Access Compliance Report

Intersection ID: 23681	Main Street: PINEVILLE-MATTHEWS_RD	Cross Street: SARDIS_PLANTATION_DR	Location: SW
ADA ID: CC1D6676CBEB	Ramp Type: Perp	Initial Pass/Fail: Fail	Overall Compliance: No
Severity Score: 21.25			
Codes/Mitigation Info/Possible Solution		Field Measurements/Component Compliance

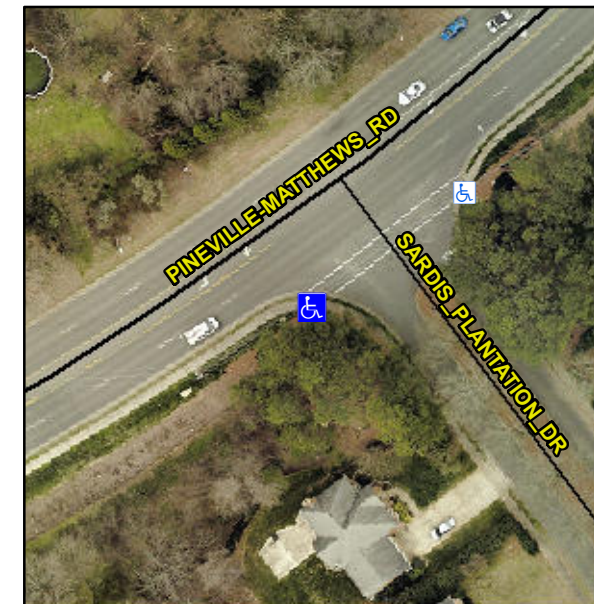
Not Found, R304.5.1, R304.2.2

Compliance	Description	Data	Compliance	Description	Data
N/A	Ramp Length (in)	84.0	No	Ramp Slope (%)	10.5
No	Ramp Width (in)	36.0	Yes	Ramp XSlope (%)	0.1
N/A	Flare Type LT	N/A	N/A	Flare Type RT	N/A
N/A	Flare Slope LT (%)	N/A	N/A	Flare Slope RT (%)	N/A
N/A	Flare Traversable LT?	N/A	N/A	Flare Traversable RT?	N/A
N/A	Landing Length (in)	N/A	N/A	DWS Provided?	N/A
N/A	Landing Width (in)	N/A	N/A	DWS Contrast?	N/A
N/A	Landing Slope (%)	N/A	N/A	DWS Length (in)	N/A
N/A	Landing X Slope (%)	N/A	N/A	DWS Full Width?	N/A
N/A	Landing Curb? (Y/N)	N/A	N/A	DWS Offset (in)	N/A
N/A	Shared Landing?	N/A			
N/A	Gutter Ponding?	N/A	N/A	Gutter Slope (%)	N/A
N/A	Gutter Lip Ht (in)	N/A	N/A	Gutter X Slope (%)	N/A
N/A	Painted X Walk1?	Yes	N/A	Painted X Walk2?	N/A
	X Walk 1 Direction	To E		X Walk 2 Direction	N/A
N/A	X Walk 1 Width (in)	104.0	N/A	X Walk 2 Width (in)	N/A
	X Walk 1 Slope (%)	0.6		X Walk 2 Slope (%)	N/A
	X Walk 1 X Slope (%)	0.2		X Walk 2 X Slope (%)	N/A

Remove & Replace Entire Ramp.
